Technical Review Comments

1st Submittal

**Re: Technical Review – Mayfair at Lawnwood
Planned Development – New Development Plan
1801 Nebraska Avenue**

Applicant's Response to Technical Review Comments

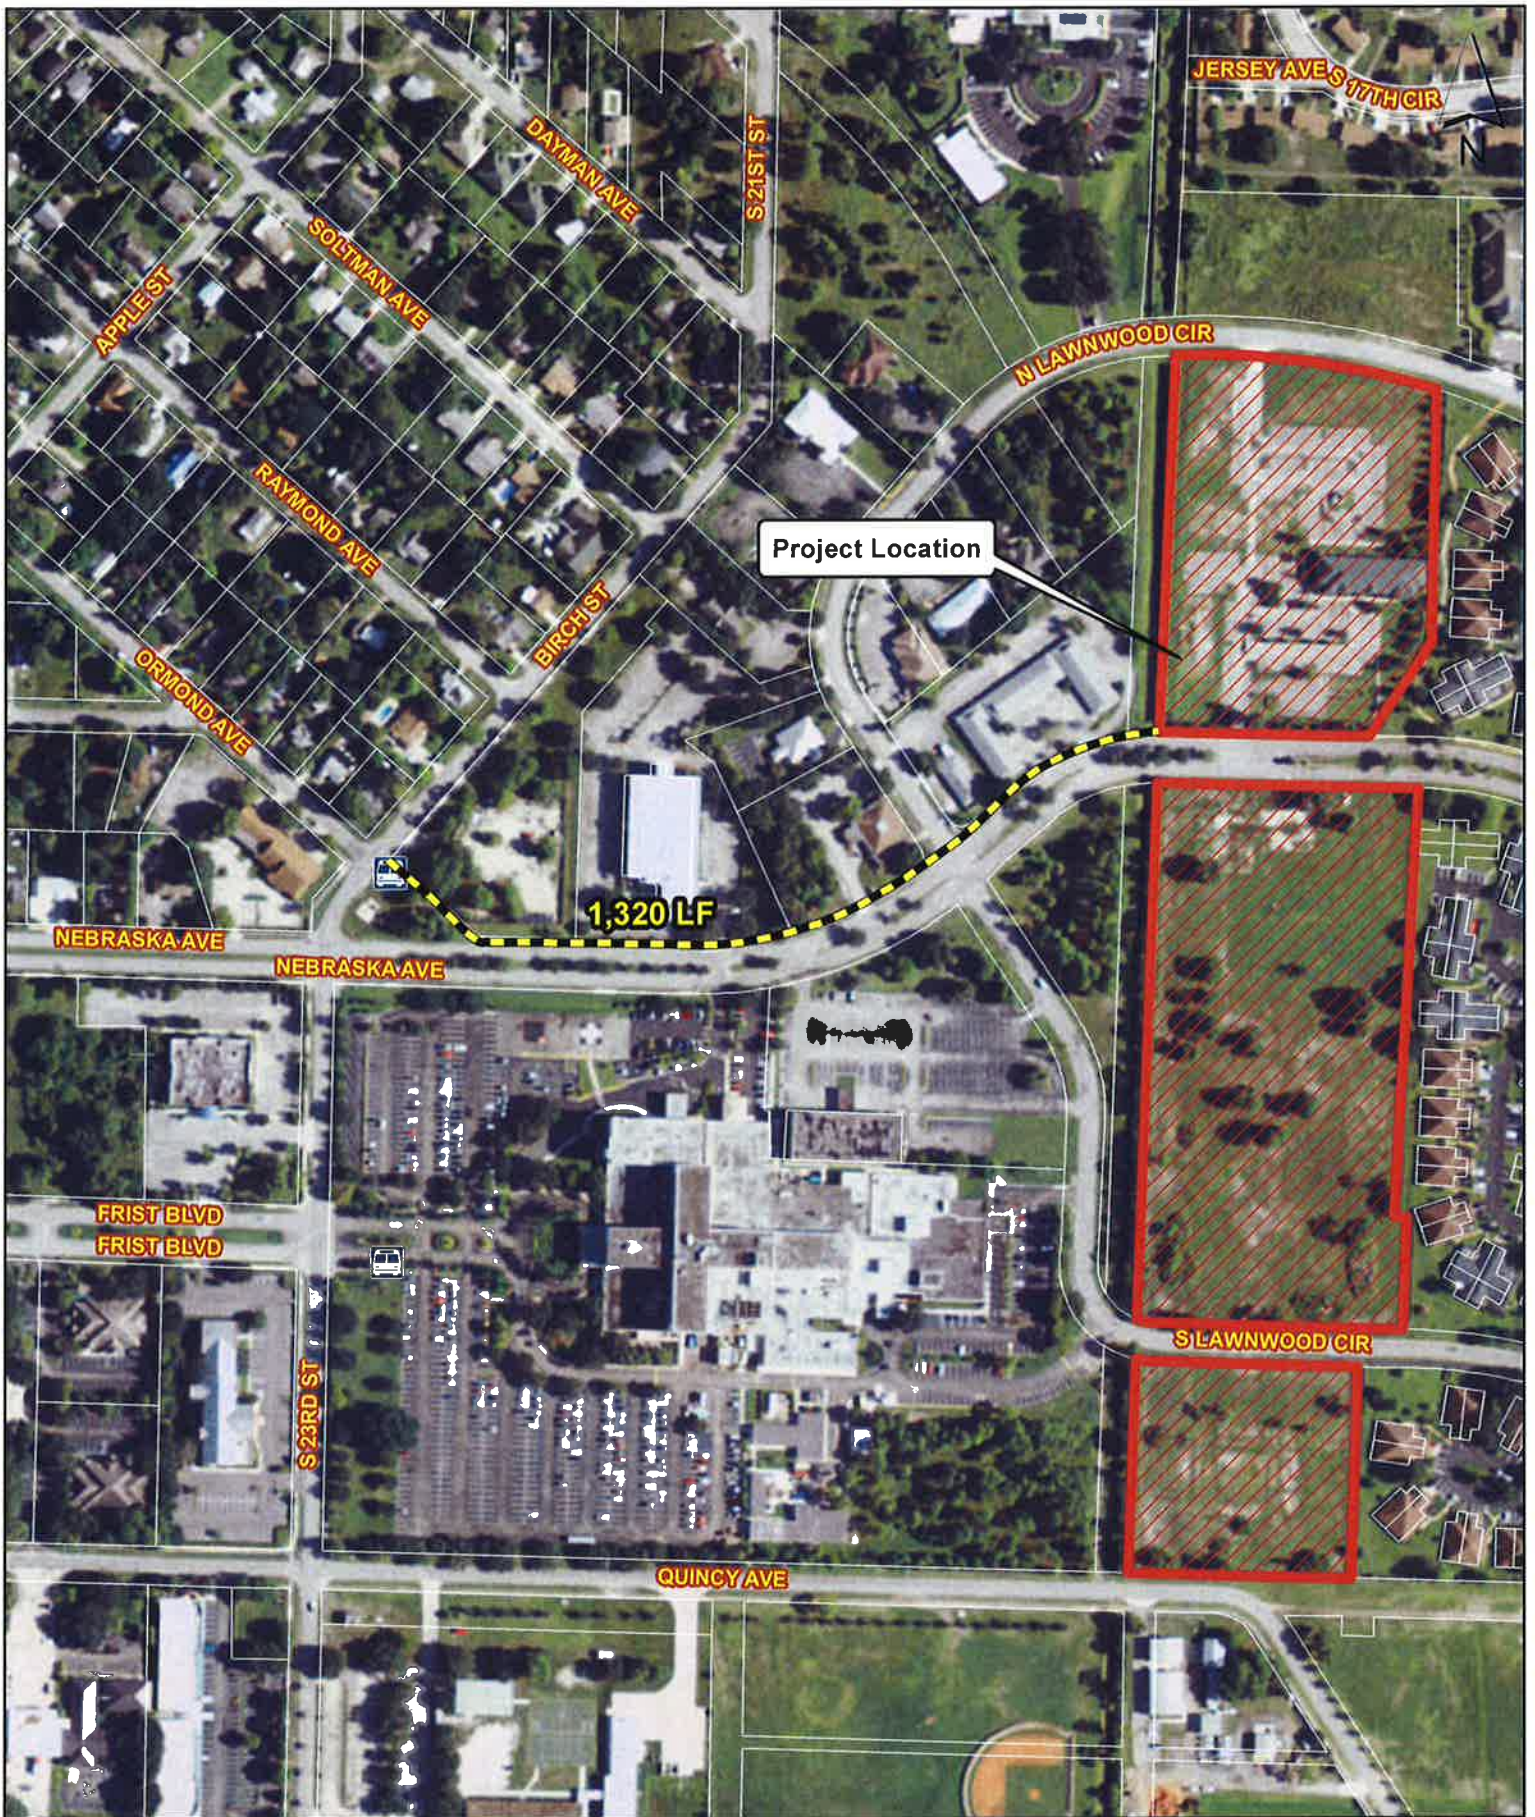
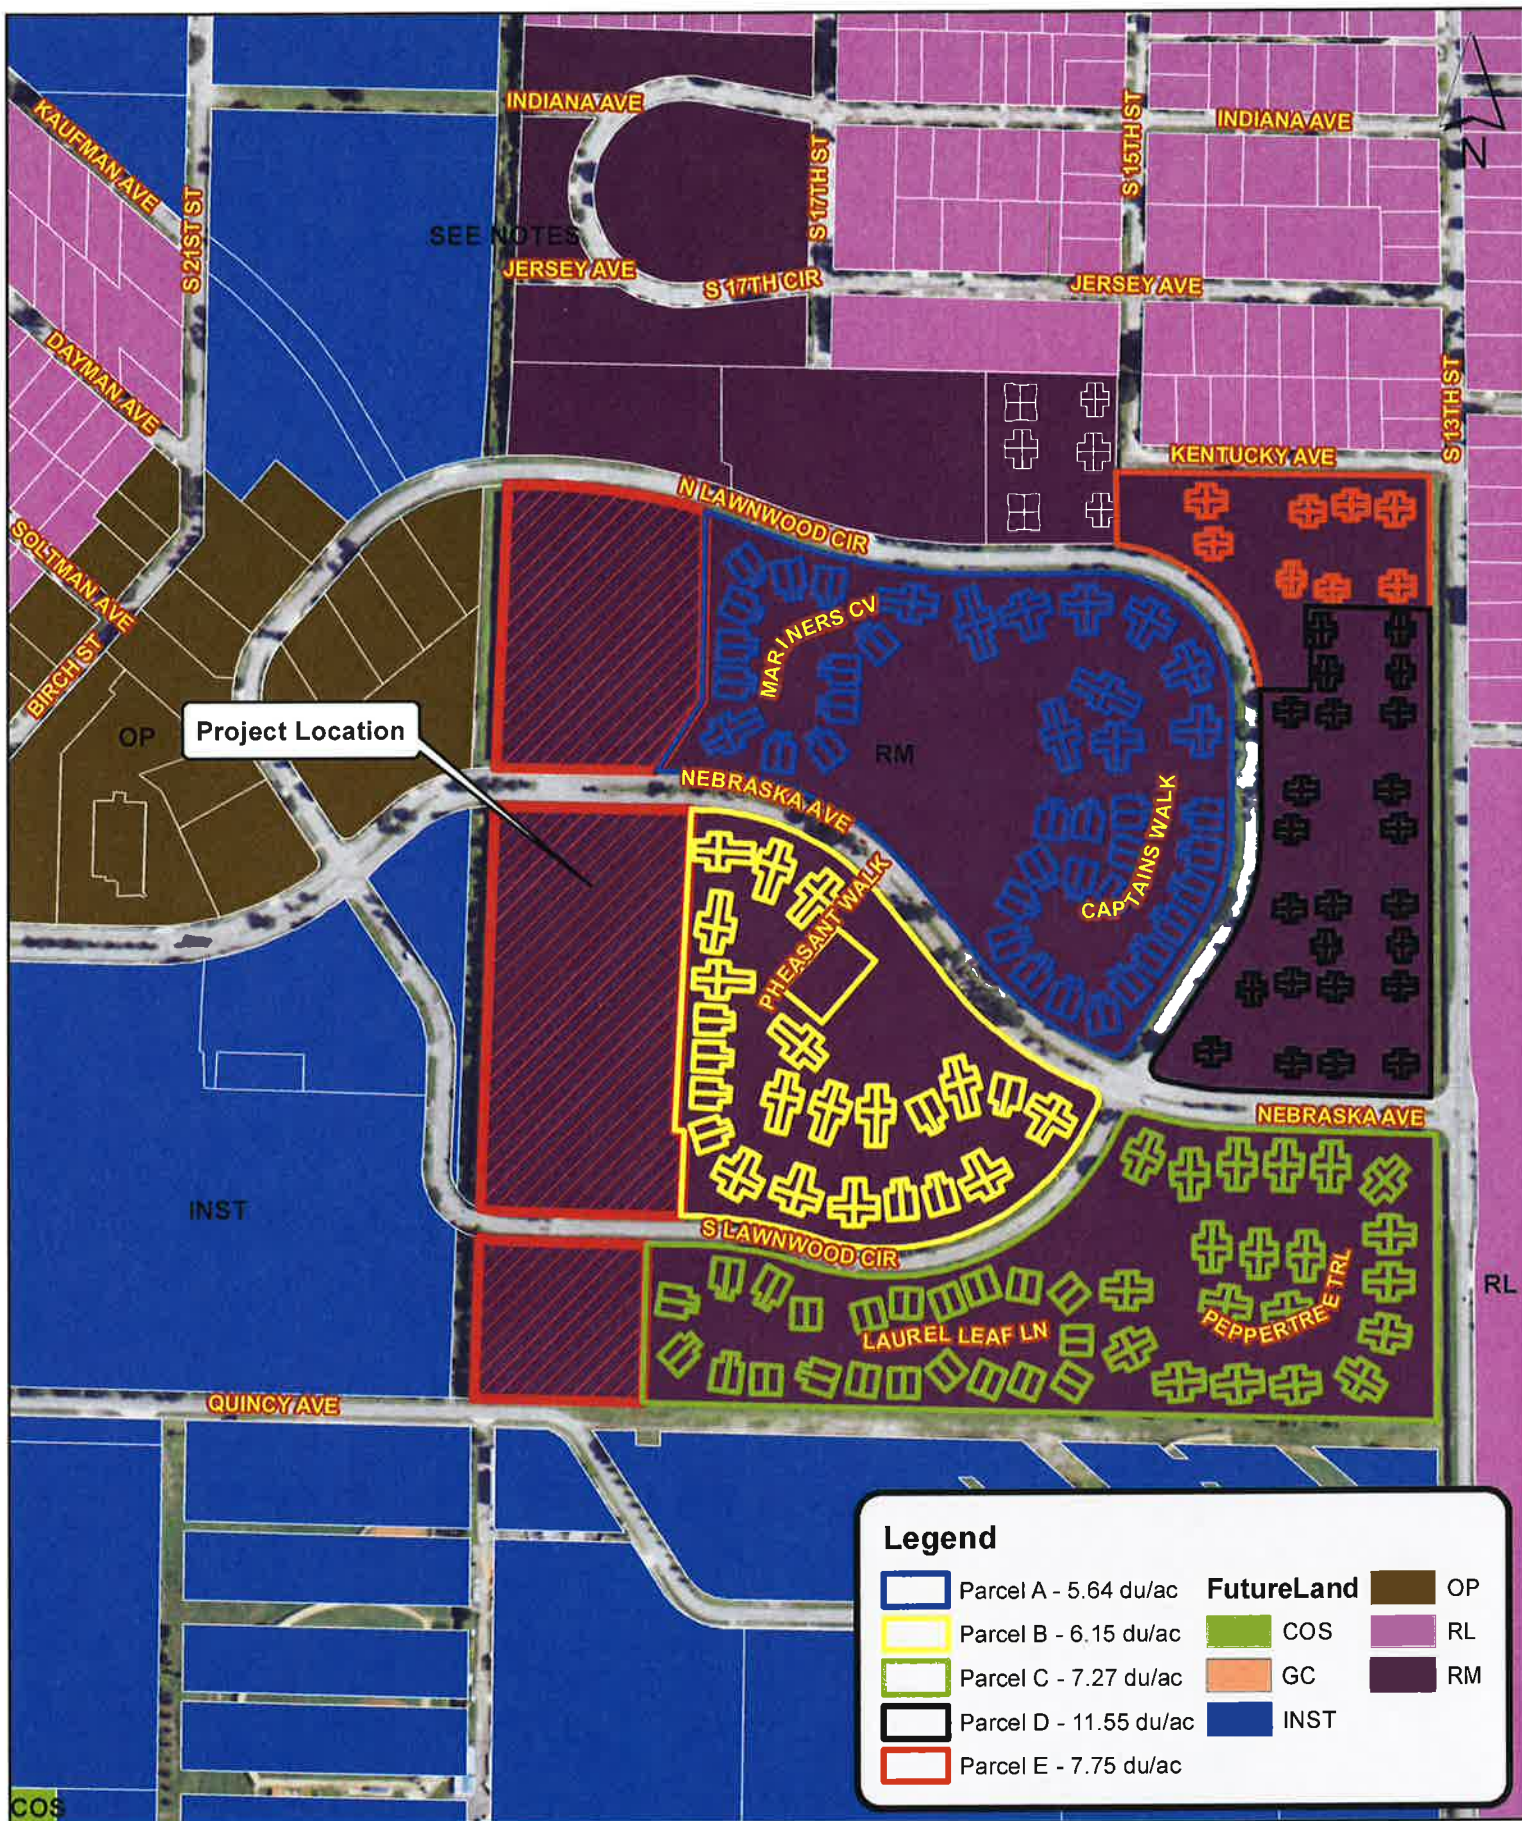
-Please update the site plan to present the noted data.

Response: A Plan showing the adjacent areas indicating the Land Use designation and densities is attached. The following tables shows the densities and the average for the area.

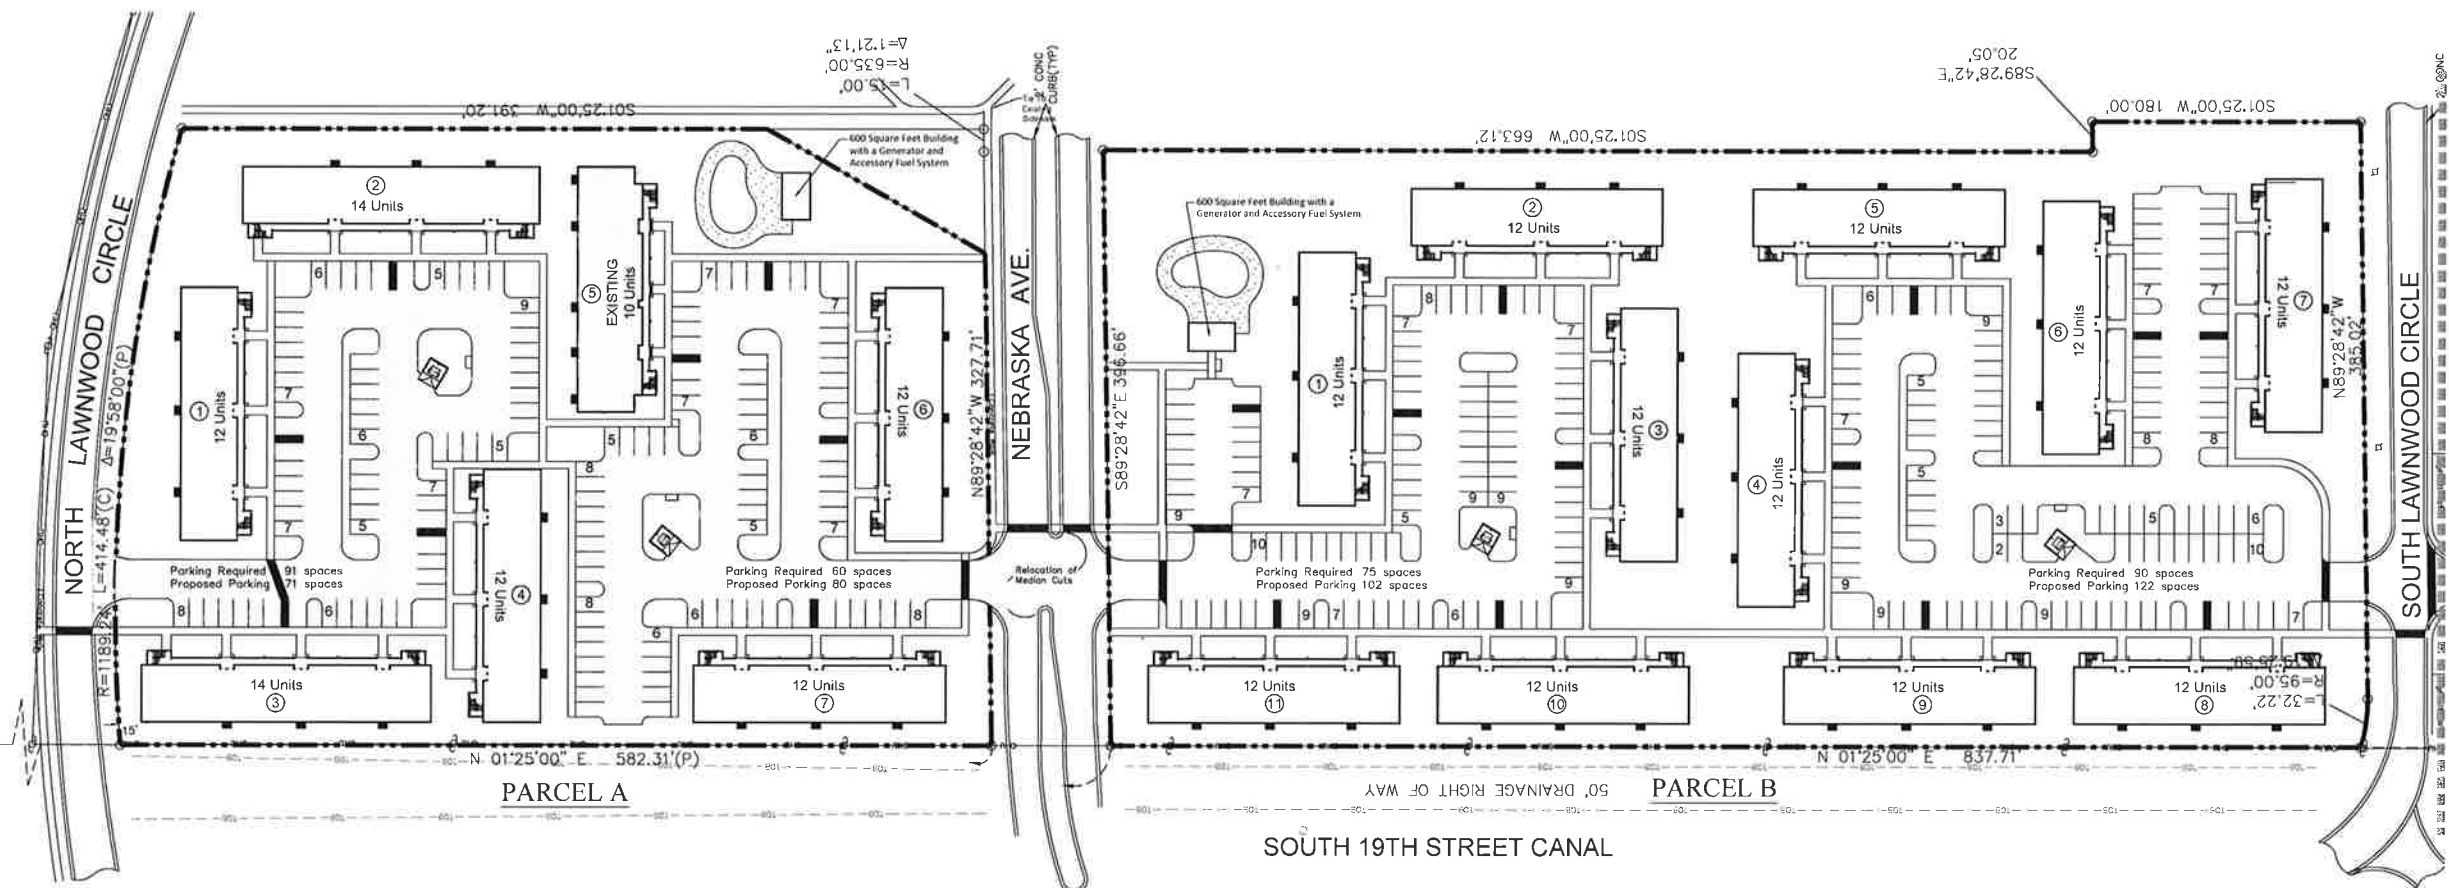
-The Density Bonus provisions sought shall be reviewed further for eligibility, within the RM district and the accompanying PD Plan. Further assessment is requested, based upon the density of the adjacent neighborhoods. Staff may be available to assist in the collaborative effort to determine the established density of the abutting Planned Development. Furthermore, the transit location does not identify the proximity to the project with regards to a safe and accessible pedestrian route. The pedestrian route calculated by staff to the nearest transit stop is approximately .55 - .6 miles.

Response: A copy of an exhibit is attached that shows the nearest transit stop. The stop is located on Birch St and Nebraska Avenue. As it can be seen the stop is 1,320 ft. (1/4 mile from the property corner on Nebraska Avenue.

MAYFAIR
 City of Fort Pierce, Florida
SITE PLAN

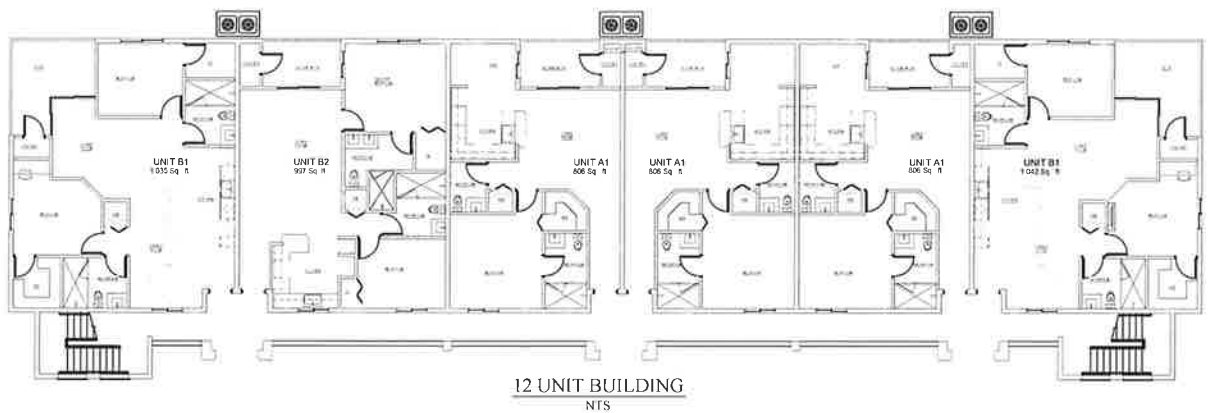
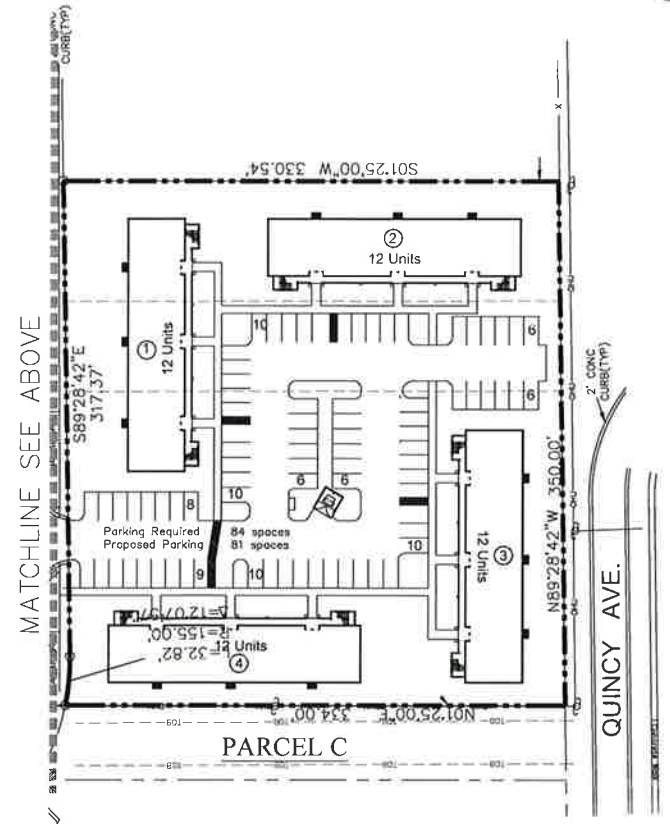
-Please provide/update the Open Space area data presented within the development plan.

-The development plan notes that no site identification or ground signs are proposed. Please review and affirm.

Response: The Site Data on the site plan has been updated to reflect the impervious/pervious values. The data has been broken down to:

Gross Area	15.8 Acres 688,248 S.F.
Building	168,142 SF
Sidewalk	41,382 SF
Paving	206,474 SF
Pool/Deck/Cabana Baths	Included in above SF
Total Impervious	415,998 SF
Total Open Space	6.25 SF 39.56 %

Response: We have added signage to the plan along the southern property. The signage is minimal and identifies "Mayfair at Lawnwood".
